**Licensing Topical Report
NEDO-33440, Revision 1
“ESBWR Safety Analyses – Additional Information
June 2009”**

NEDO-33440

June 2009

ESBWR Safety Analysis - Additional Information

RAI 6.2-98 S01 Figure 6.2-98 S01-1. DCD TRACG Nodalization of the ESBWR RPV

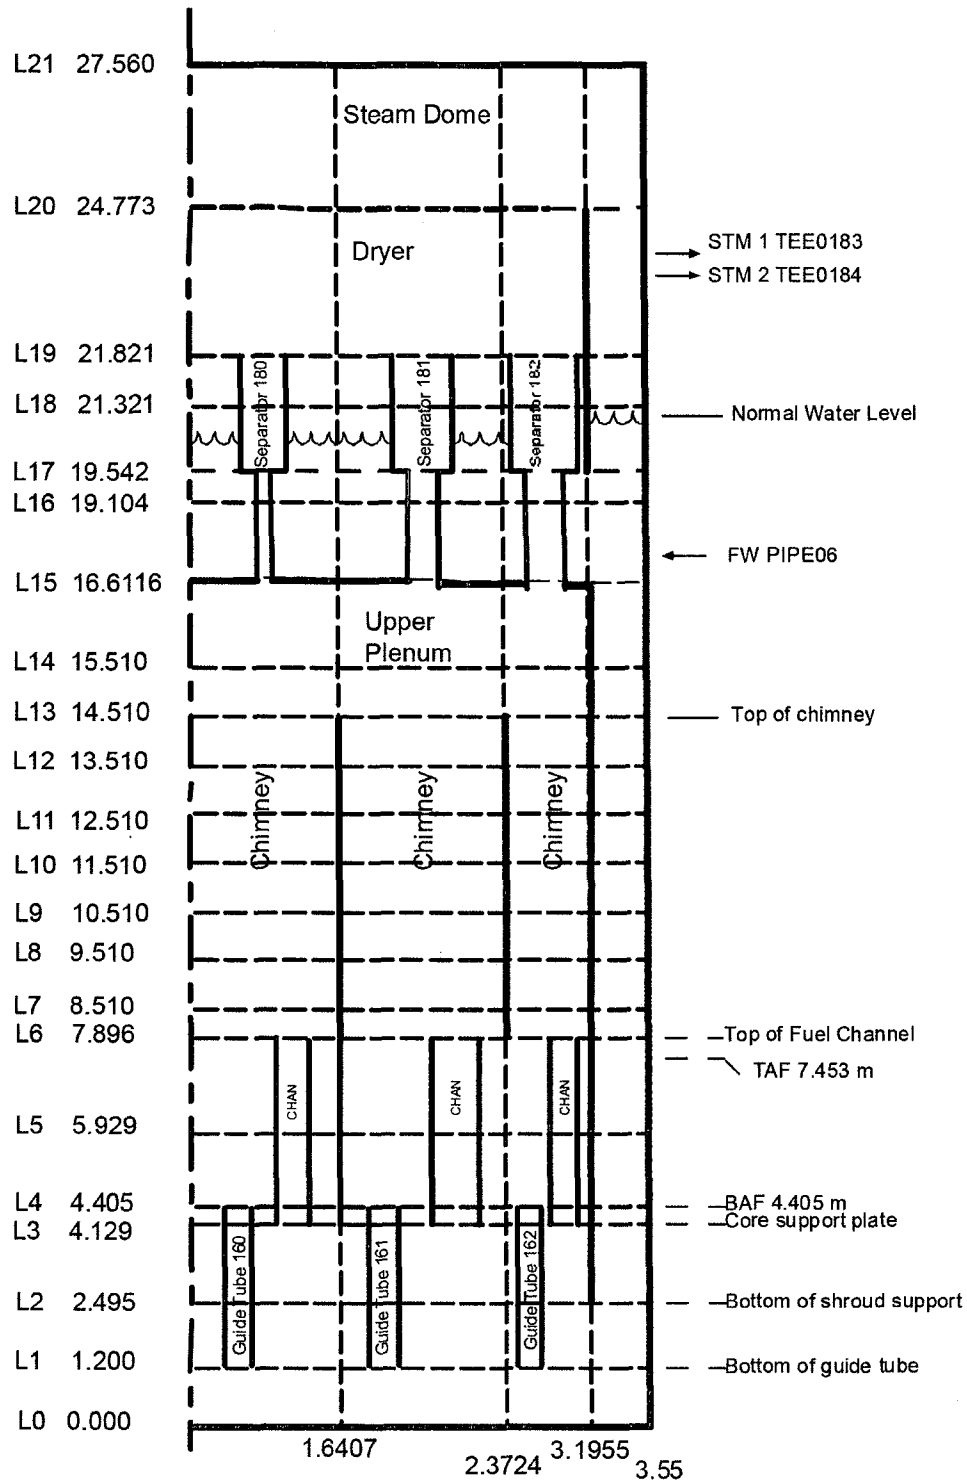
14. Provide all nodalization changes including diagrams since the approval of TRACG for ESBWR LOCA Analyses in Reference 2, include most recent changes incorporated into Rev. 2 of the DCD; Explain the statement in Reference 3 that a "Total of 5 chimneys to calculate the minimum water level." In the TRACG input decks submitted to the staff and in Figures 6.2-6 and 6.2-7, the core/chimney section is divided into only 3 rings.
